**Responses to NRC Requests for
Additional Information Dated
February 12, 2016
Sweetwater Uranium Project
Docket Number: 40-8584
Source Material License SUA-1350**

June 2016

Prepared for:
Kennecott Uranium Company
P.O. Box 1500
Rawlins, Wyoming 82301-1500

Prepared by
**Telesto Solutions Inc.
3801 Automation Way, Suite 201
Fort Collins, Colorado 80525**

Figure 1 2015 Contaminant Bounds from Historical Releases

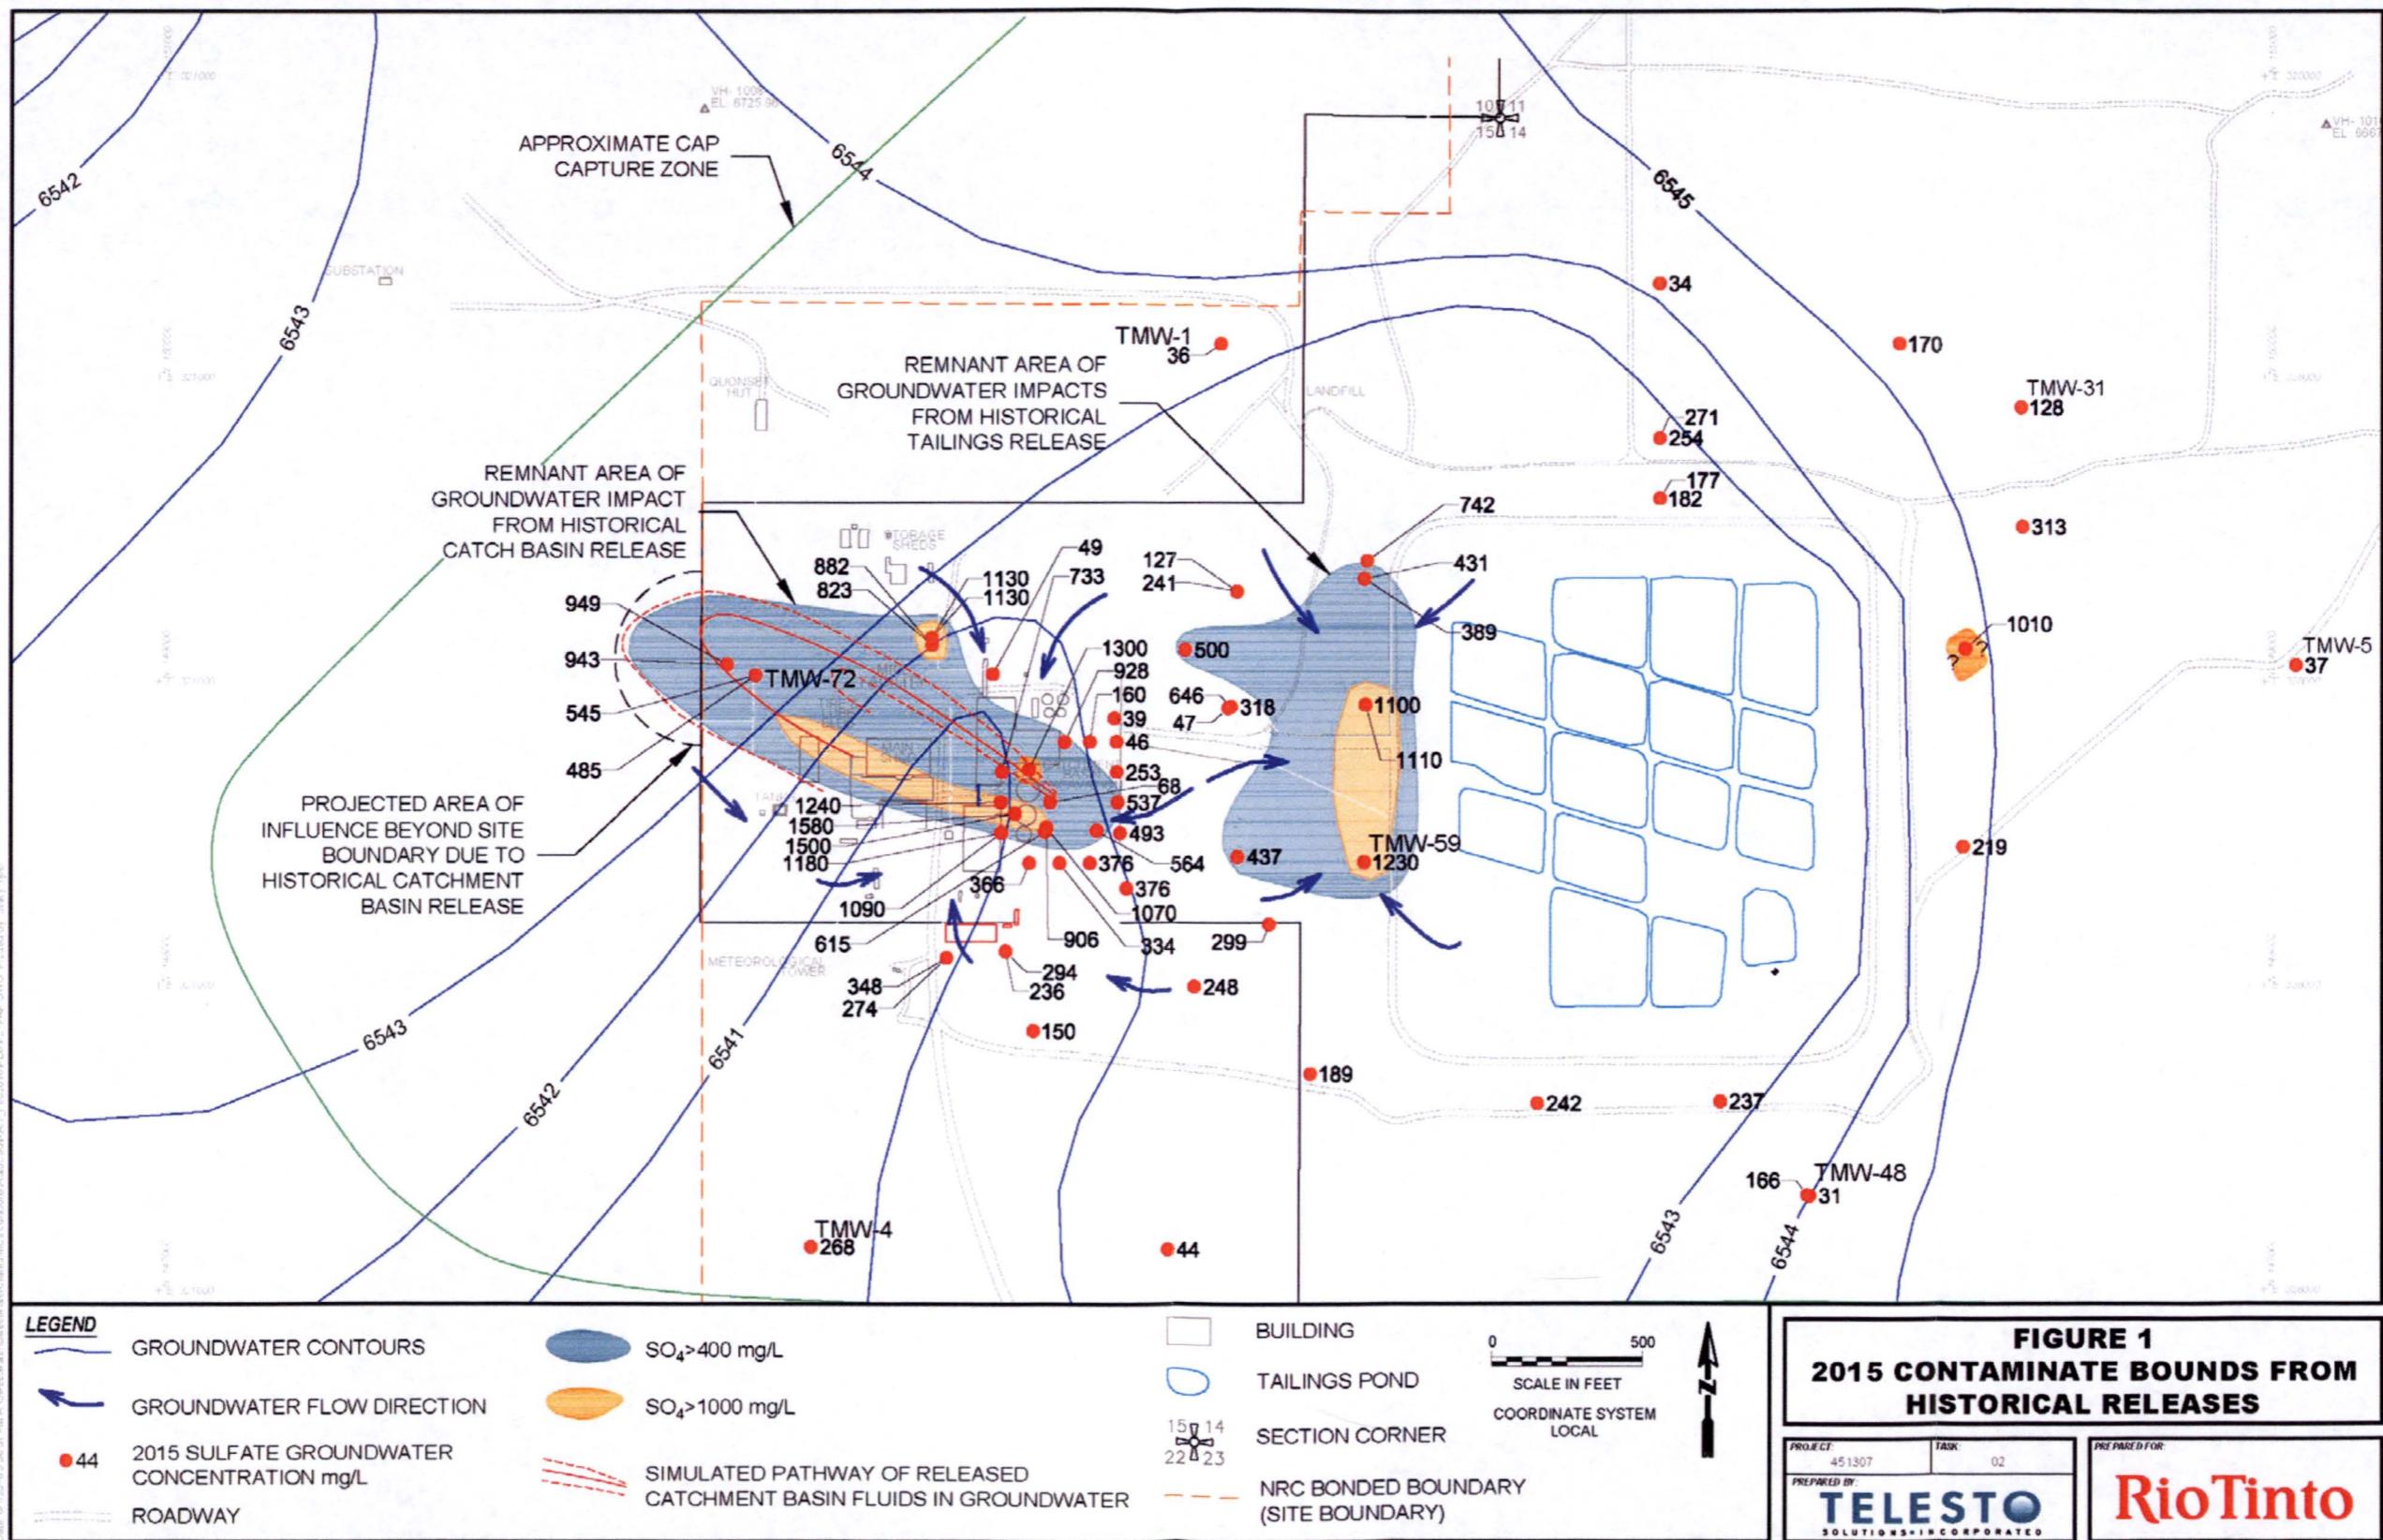
For the environmental impacts on water resources provide the following: a) is the current contamination discussed in (KUC, 2014) from i) an existing leak, ii) a previous leakage that has been repaired, or iii) a combination of (i) and (ii)?; and iv) if the answer for (a) is (a,ii) provide the technical basis as to why the contaminants have not been contained for more than 30 years since the leakage from the tailings impoundment synthetic liner was repaired in 1984, despite that a Corrective Action Program is in place to contain the contamination; b) address impacts of contaminants leakage on surface water and ground water resources for i) standby mode, and ii) future operation mode as more contaminants will be generated; c) address spread of the contaminants discussed in (KUC, 2014) beyond the site boundary including the

following: i) impacts on surface water resources, ii) impacts on ground water resources, iii) monitoring measures, and iv) mitigation measures.

Figure 1 provides a synopsis of the current groundwater impacts from the historical tailings and catchment basin releases. The area of influence from the tailings release is contained beneath the tailings impoundment footprint and extends to the west approximately 500 feet. The area of influence from the catchment basin release is currently projected to extend approximately 250 feet west of the site boundary (defined as the NRC bonded area boundary). There is a **chance** that some of the fluids have migrated beyond the NRC's bonded area boundary. KUC has put forth a plan (Telesto, 2015b) to the NRC to characterize this potential and is awaiting concurrence. Depending on the results, KUC is committed to expanding the CAP to ensure continued containment should it be determined that remnant process fluids have traveled beyond the current CAP influence.

Telesto (2009) describes the contaminant fate and transport mechanisms that resulted in the distributions shown in Figure 1. No surface waters exist in the vicinity and therefore, no impacts to surface waters have taken place due to the historical releases from the catchment basin and tailings.

KUC will continue to monitor groundwater throughout its operational boundary irrespective of operational status. The spot sulfate concentrations shown in Figure 1 are an example of recent monitoring efforts. KUC has proposed to extend the monitoring system to the west of the site boundary in order to determine if effects from catchment basin seepage are within the projected area of influence as shown in Figure 1, and is awaiting NRC concurrence with the plan.

The CAP, approved by the NRC, is the mitigation measure implemented by KUC to contain both the tailings and catchment basin releases. The primary component of the CAP is hydraulic containment, which (based upon existing measurements and groundwater simulations) appears to be functioning as planned. Figure 1 shows the current capture zone of the CAP system.
